Monroe Planning Commission Agenda

Tuesday, April 20, 2021

DATE: April 20, 2021
RE: Information Packet for April 20, 2021 Planning Commission Meeting at 6:00 p.m.

I. Case No. 2021-1-1 (TABLED)—Consideration of a Site Plan for Thornton's

MONROE THORNTONS	DRAFTING: PJT	DATE: 10/16/2020
	DESIGN: JPS	SCALE: 1" = 20'
	OVERALL SITE PLAN

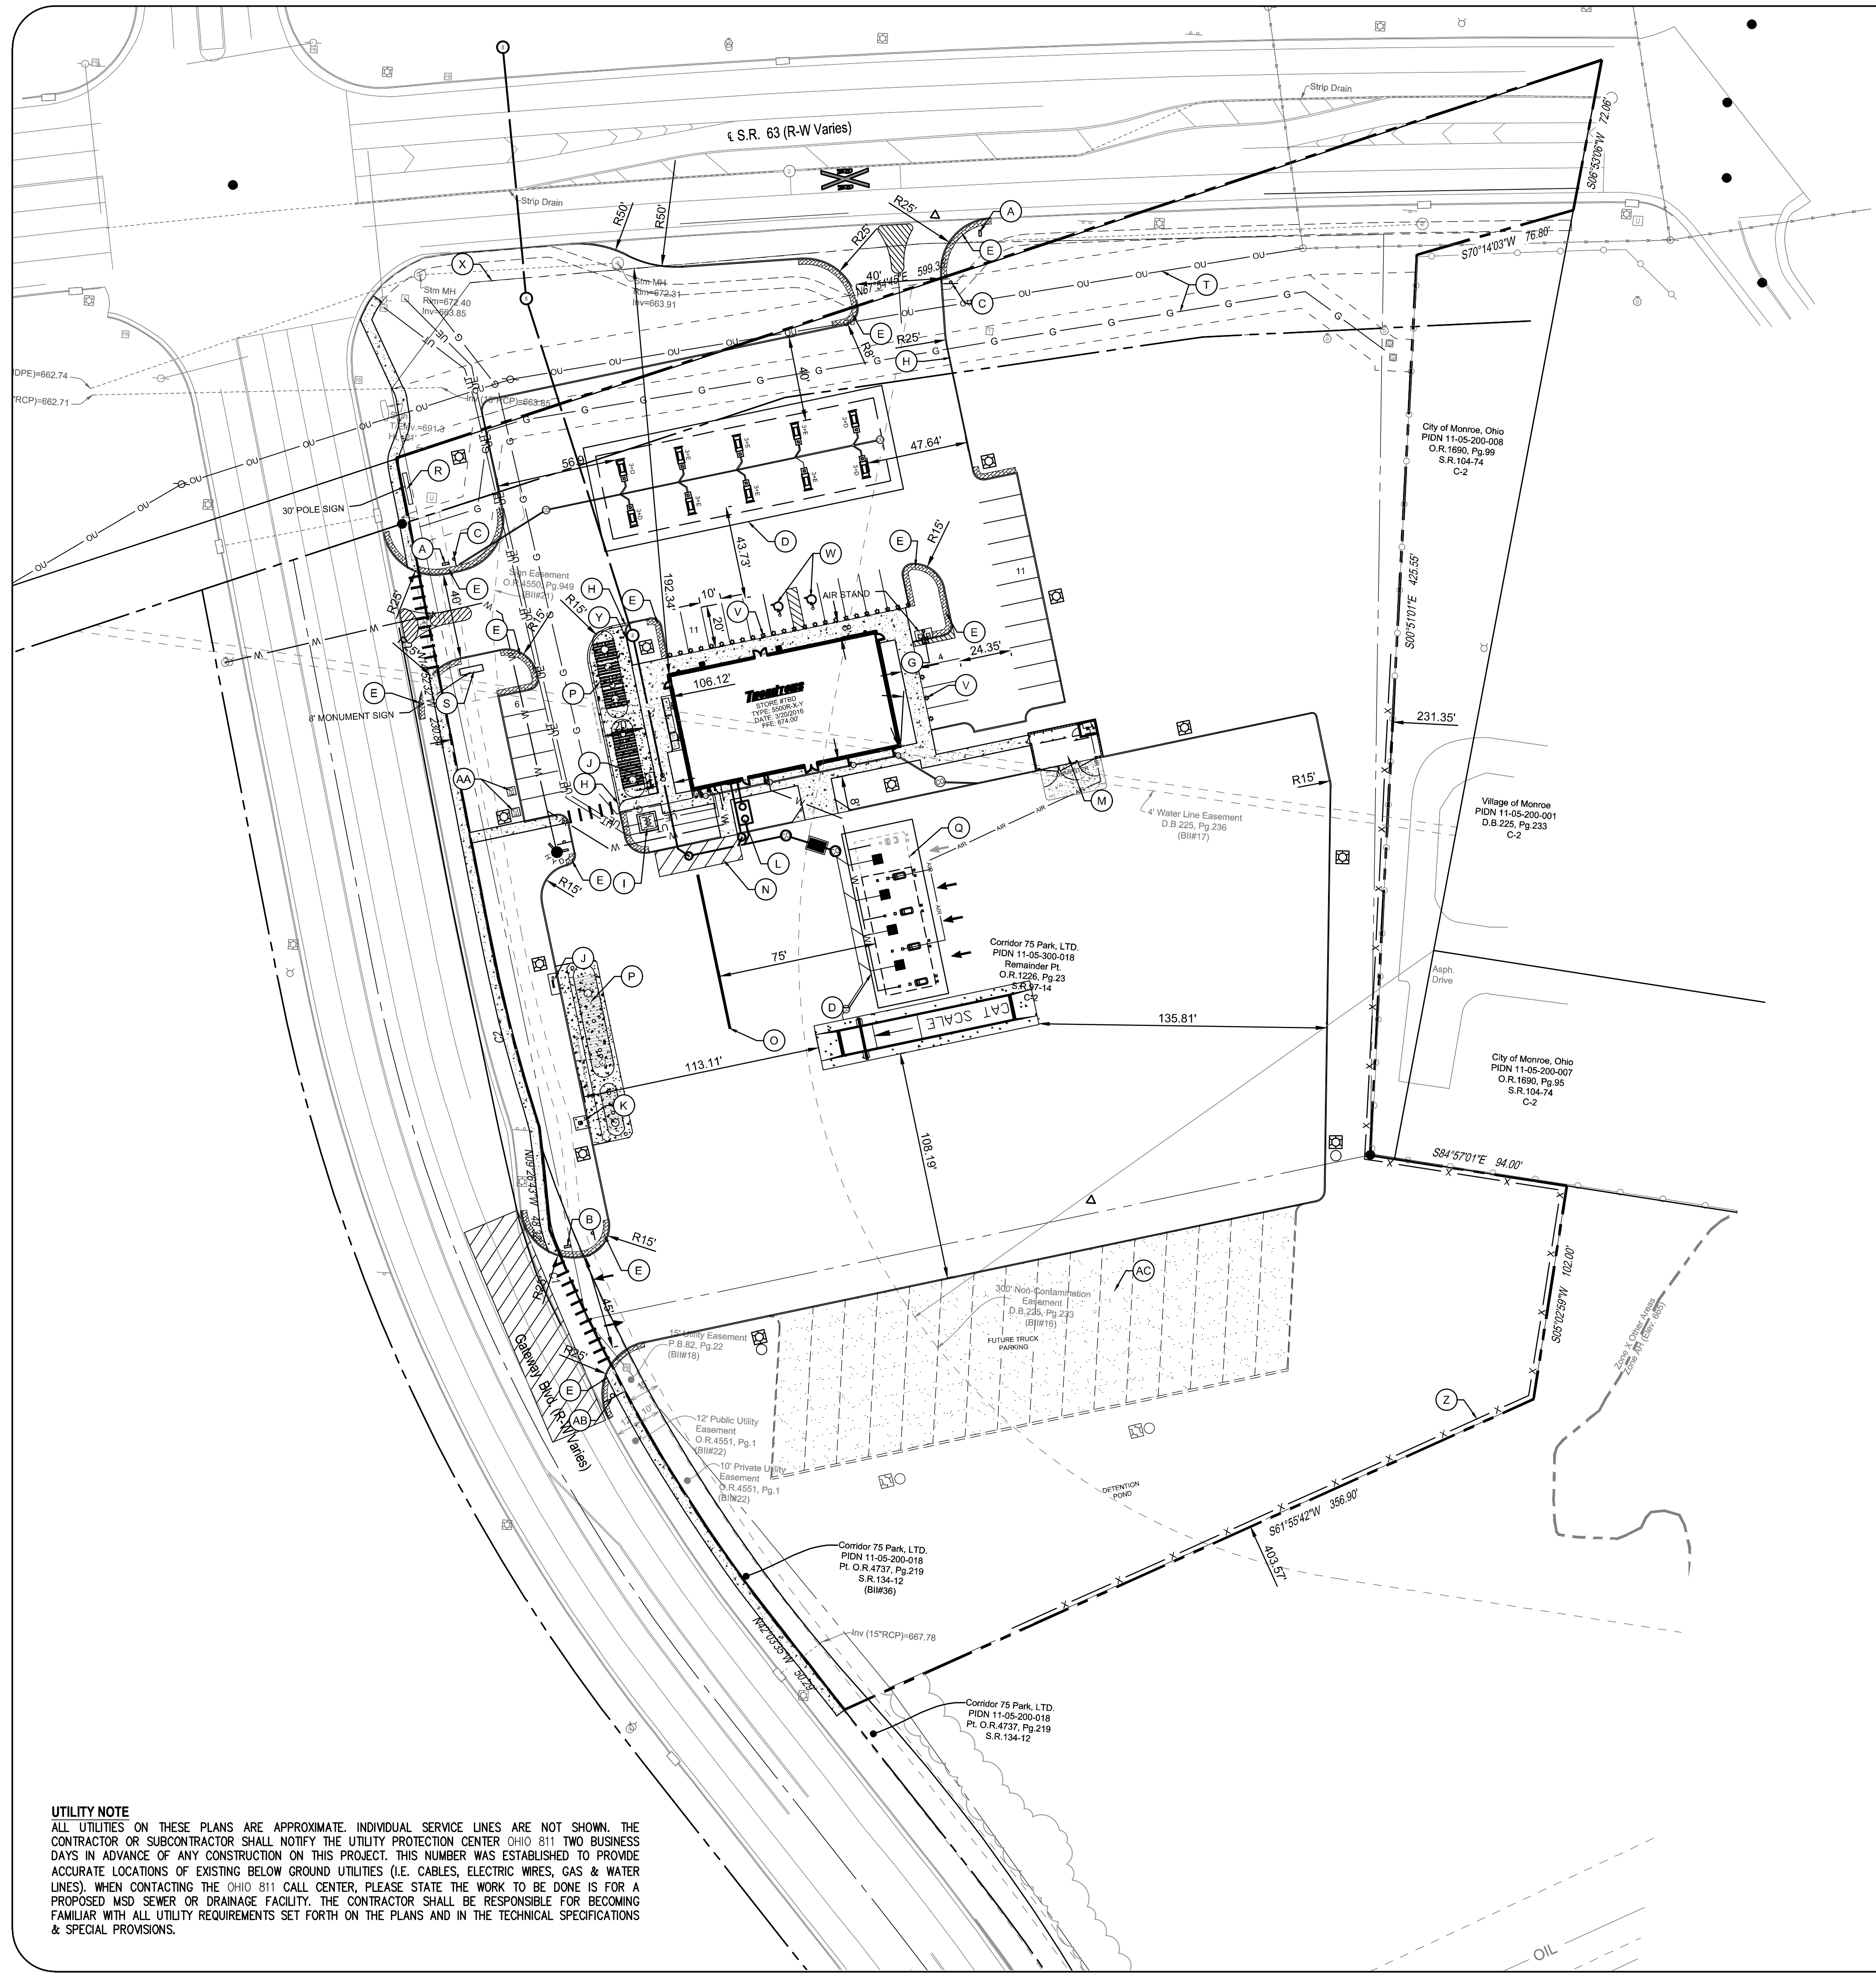
- While not reviewed during the Planning Commission process, a portion of the sign package proposal is prohibited per code:
 - The 30-foot pole sign shown on the overall site plan is not permitted in the C-2 zoning district and must be removed from all plans as to not indicate/cause confusion with approval authority or process (1214.10 Table 1214-1).

- Per revised civil plans submitted by the applicant, semi parking stalls are now shown as “future truck parking”. These stalls and labeling must be eliminated from the site plan as part of the use requirements as it is not permitted. Any reference to “future stalls” can cause confusion with the plan and could be construed as approved via site plan approval **(1204.04(D) (15) and (1204.04(D)(4))**.

- The fuel canopy is required to be 15 feet from closest point of right-of-way. While not clearly identified on the site plan, further review has shown the canopy is located partially within the right-of-way as identified generally by the blue highlight on site plan image on the next page (yellow indicates proposed property line and red indicates a proposed right of way line). This requirement is not met and will need to be corrected, which may require other site plan adjustments **(1204.04(D) (15) and (1204.04(D)(4))**.

- Right-of-way sidewalks (5-foot minimum width) are required along on Gateway Boulevard and State Route 63. Though Planning Commission has previously waived this requirement for walks along State Route 63, and while the applicant now shows where a sidewalk could be located for future purposes, it needs to be officially engineered based on the next comment **(1208.07)**.
- As was previously indicated, Planning Commission has periodically delayed the required installation of the sidewalk along the State Route 63 frontage. After further review and research, Staff is recommending installation of the walk concurrently with site development as this property represents the eastern border of the City and a logical starting point for an east-west pedestrian/trail connection which is further bolstered by the Lebanon-Turtlecreek Trail Initiative for connections in this area. **(1208.07)**.

MONROE THORNTONS		DRAFTING: PDT	DATE: 10/16/2020
		DESIGN: JPS	SCALE: 1" = 20'
LANDSCAPE PLAN

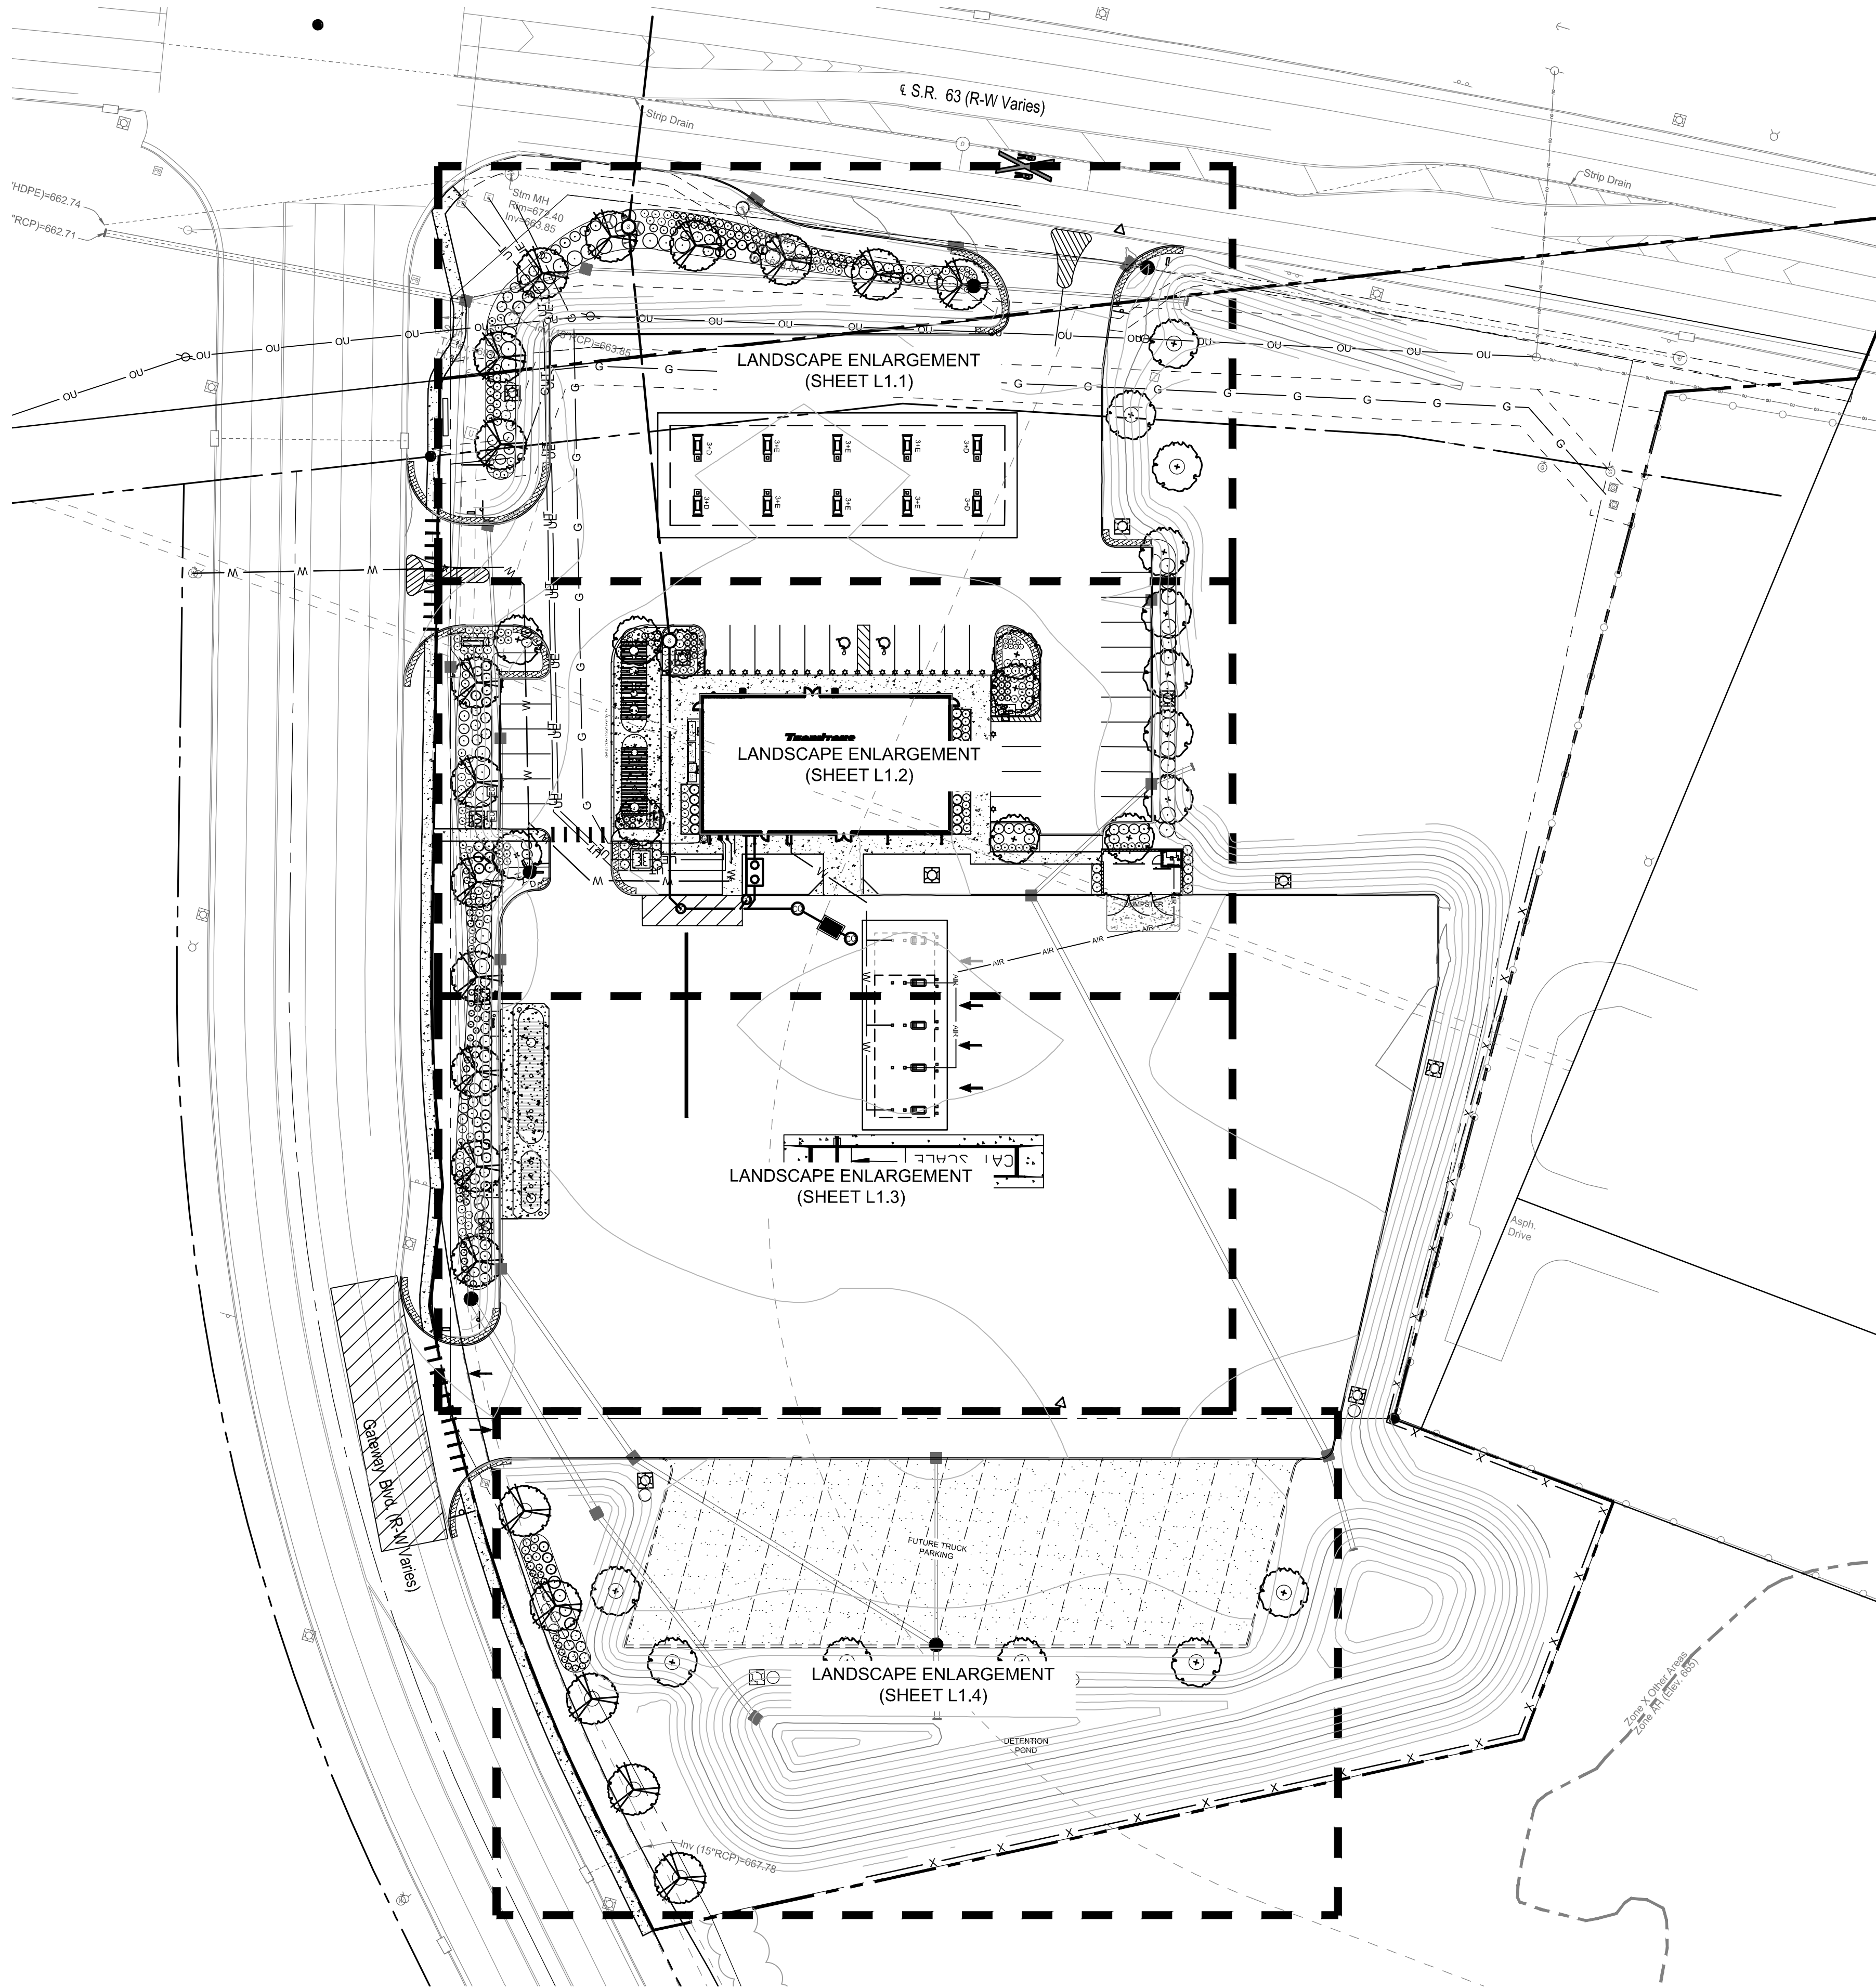
- The other plantings do not meet this height requirement, do not meet the evergreen requirement, or do not meet either requirement (See in yellow the boxwood that meets the species requirement but not the height requirement).

- While Staff appreciates and encourages a diversity of plantings, please revise to show 36" evergreen species to provide appropriate coverage across the entire parking row.

- The screen of shrubs proposed on the east side parking row shows the appropriate size and species, however, the number of shrubs appears to be insufficient for full screening coverage unless the width of each plant is approximately 5 feet wide. If solid screening is not achieved with the number of shrubs currently shown, additionally plantings will be required at time of zoning compliance inspection.
- A parking island with associated landscaping is required on the north end of the western parking row. Please revise **(1212.07(B))**.

- As a reminder, full screening of service structures is required. This would include any rooftop or ground mounted equipment proposed now or determined necessary during the construction of the development.
 - It appears the southern side of the transformer is left open/unscreened **(1212.09(A))**.
- Front yard landscaping requires 20% of the required front yard area (20% of 50 feet being 10 feet) be landscaped areas with a minimum 6 feet against the right-of-way along the edge of the property.
 - While the applicant has shown the 20% total area is met, Staff requests the applicant show the minimum 6 foot landscaped area along both Gateway Boulevard and State Route 63 **(1212.08(A))**.

NORTH ELEVATION

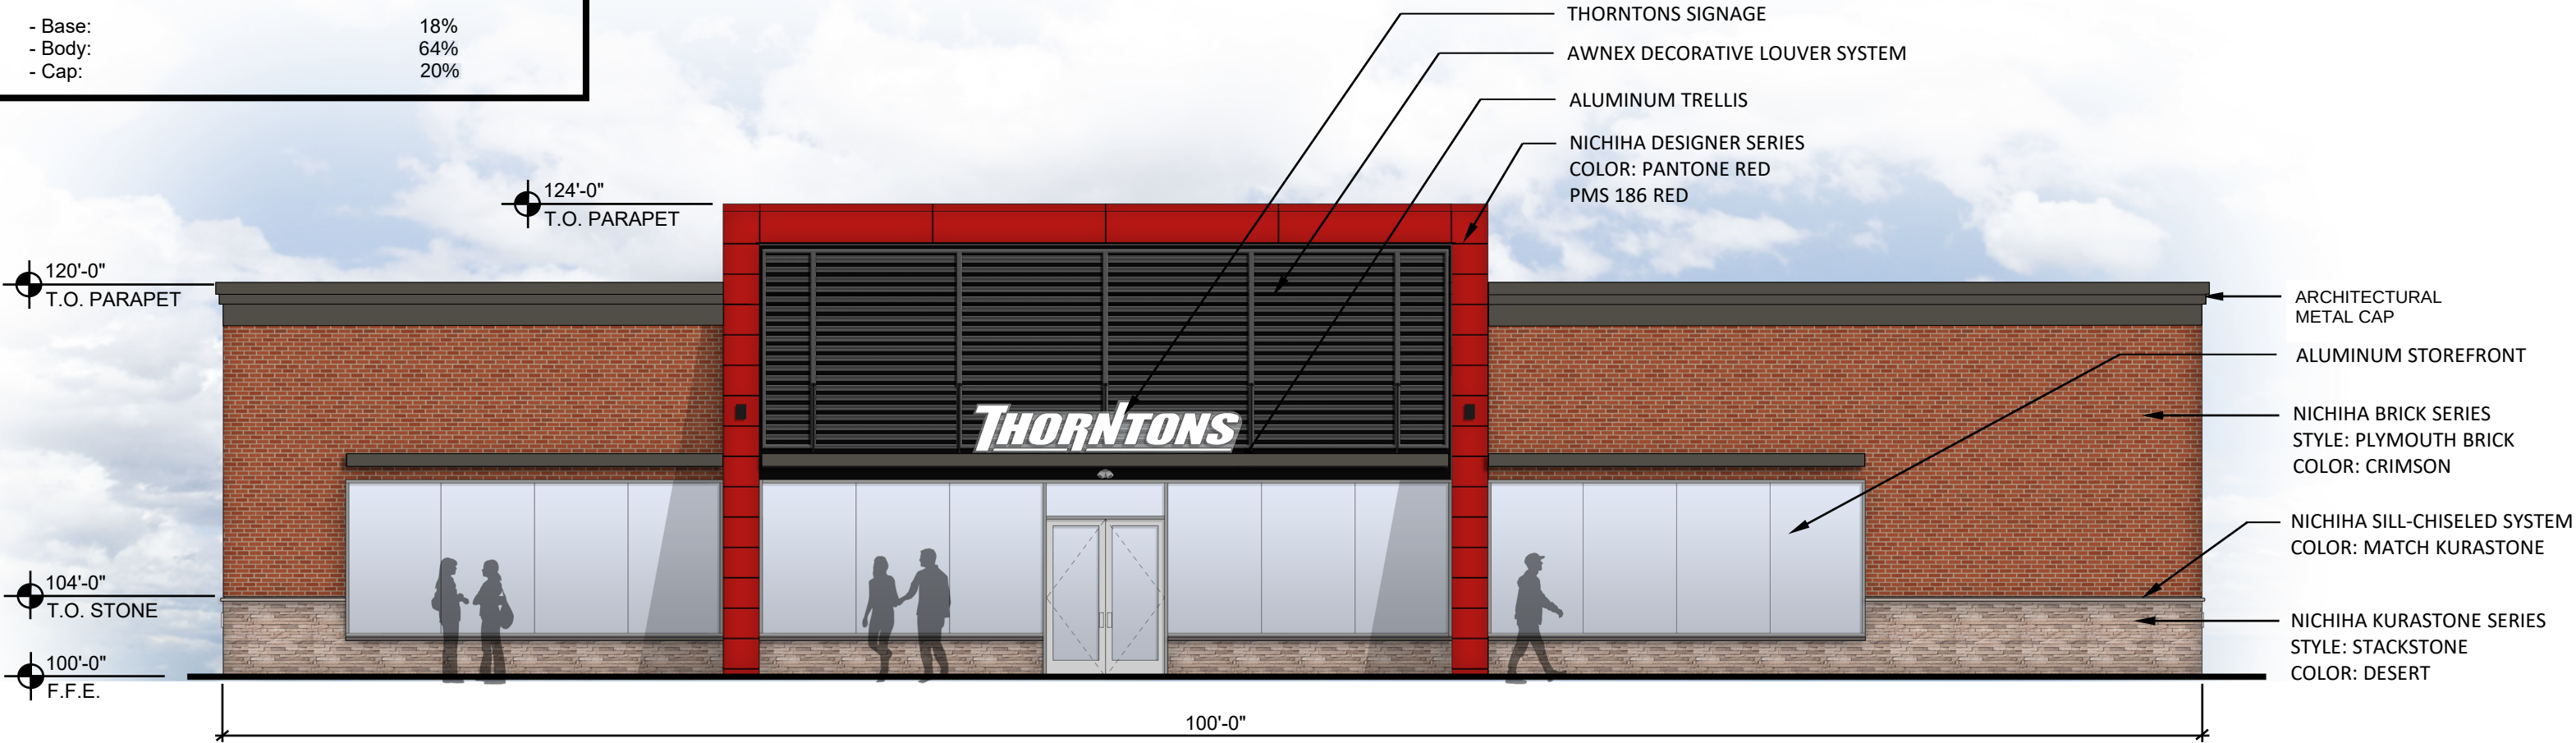
- 25% of wall area visible from a right-of-way/public road must contain windows. As the site has visibility from multiple points on Gateway Blvd and State Route 63, this window requirement applies to the south, east, and west sides in addition to the north side. The south side of the building does not meet this code requirement with almost no glass/window area proposed. Please revise **(1210.05(D)(5))**.

- All walls visible from a public street that are at least 60 feet wide must incorporate offsets of at least 2 feet deep and 20 feet wide at a minimum of every 40 feet. This requirement applies to both the north and south sides of the building **(1210.05(D)(4))**. Please revise to meet this code requirement or provide one of the following alternatives:

- The applicant has updated architectural elevations to appear to comply with this section.
- Base-body-cap percentages need to be indicated to show minimum 8% base and 8% cap across the entire building. While it appears the 8% base requirement is met on the majority of the building, it is not met on the north elevation and will require revision. Further, the cap proposed may not meet the 8% minimum required. Please provide accurate percentages

- The applicant has updated architectural elevations that appear to comply with this section. However, as the above comment stated previously, it appears the base-body-cap percentages incorrectly account for the black and red metal entrance features when only the architectural metal cap, which is the overall cap area spanning the majority of the building, should be accounted for as the 8% cap.

- Further evaluation of the proposed metal on the structure as architectural requirements states: *(3) Exposed metal panels (such as corrugated metal) shall be prohibited in the C-1, C-2, C-3, and C-4 districts. This subsection shall not be construed to prohibit metal roofs, flashing, aluminum storefront associated with windows, or high-quality metal siding such as copper, bronze, or other decorative metal, which may be used on a case-by-case basis.* Please provide more detail, example images, etc. on this metal material **(1210.05(D)(3))**.
